<b>Title - Sujet</b> Light Icebreaker	
<b>Solicitation No. - N° de l'invitation</b> F7013-180034/C	<b>Amendment No. - N° modif.</b> 004
<b>Client Reference No. - N° de référence du client</b> F7013-180034	<b>Date</b> 2020-05-04
<b>GETS Reference No. - N° de référence de SEAG</b> PW-\$\$MB-007-27711	
<b>File No. - N° de dossier</b> 007mb.F7013-180034	<b>CCC No./N° CCC - FMS No./N° VME</b>
<b>Solicitation Closes - L'invitation prend fin</b> <b>at - à 02:00 PM</b> <b>on - le 2020-06-16</b>	<b>Time Zone</b> <b>Fuseau horaire</b> Eastern Daylight Saving Time EDT
<b>F.O.B. - F.A.B.</b> <b>Plant-Usine:</b> <input type="checkbox"/> <b>Destination:</b> <input checked="" type="checkbox"/> <b>Other-Autre:</b> <input type="checkbox"/>	
<b>Address Enquiries to: - Adresser toutes questions à:</b> Martin, Erik	<b>Buyer Id - Id de l'acheteur</b> 007mb
<b>Telephone No. - N° de téléphone</b> (613) 296-7863 ( )	<b>FAX No. - N° de FAX</b> ( ) -

This Amendment No.004 is raised to (1) make modifications to the Request for Proposal and (2) answer questions from the industry.

Fig. 11. Classical ice breaking bow shape (top) and modern icebreaker (bottom).

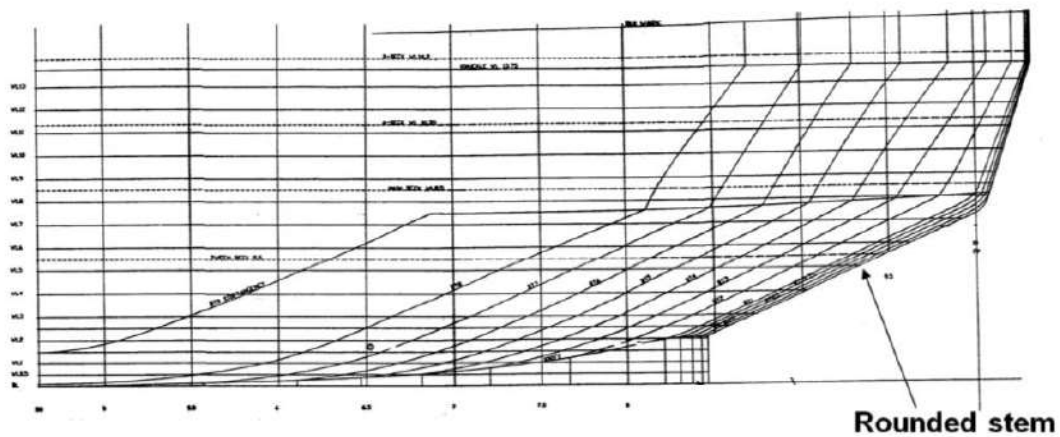
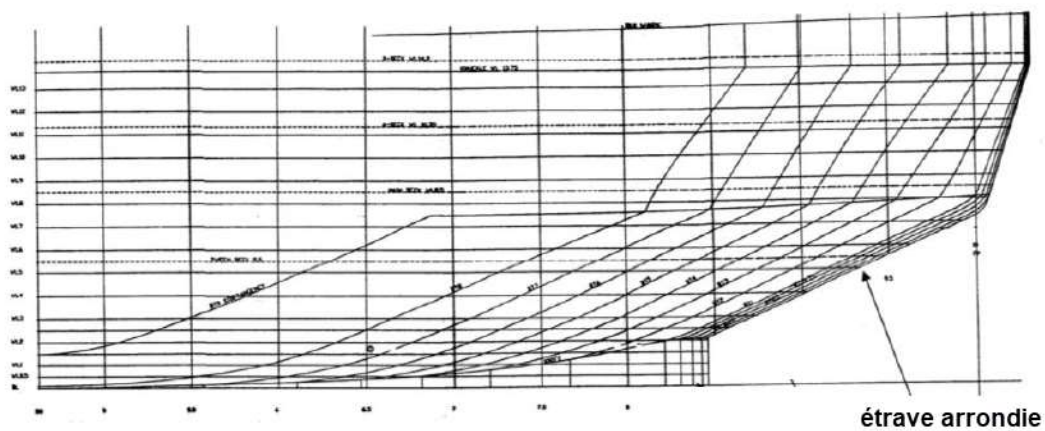
*Mandatory criterion MR-1A also requires that the vessel has a rounded stem. Can Canada define what this means, and why it is required? Many types of stem are used in icebreaking vessels.*

Rounded stem is defined as the design element where the bow angle is significantly reduced and has a rounded shape to decrease the crushing force at the stem during icebreaking. See attached graphic for a visual representation.

A rounded stem is a mandatory requirement as this is the standard stem design on Canadian Coast Guard icebreakers and will thus allow crew from the existing fleet of vessels to quickly become familiar with operating this new vessel. This quick transition and reduced training requirement have been deemed essential for the on-time operationalization of the Light Icebreaker post conversion.
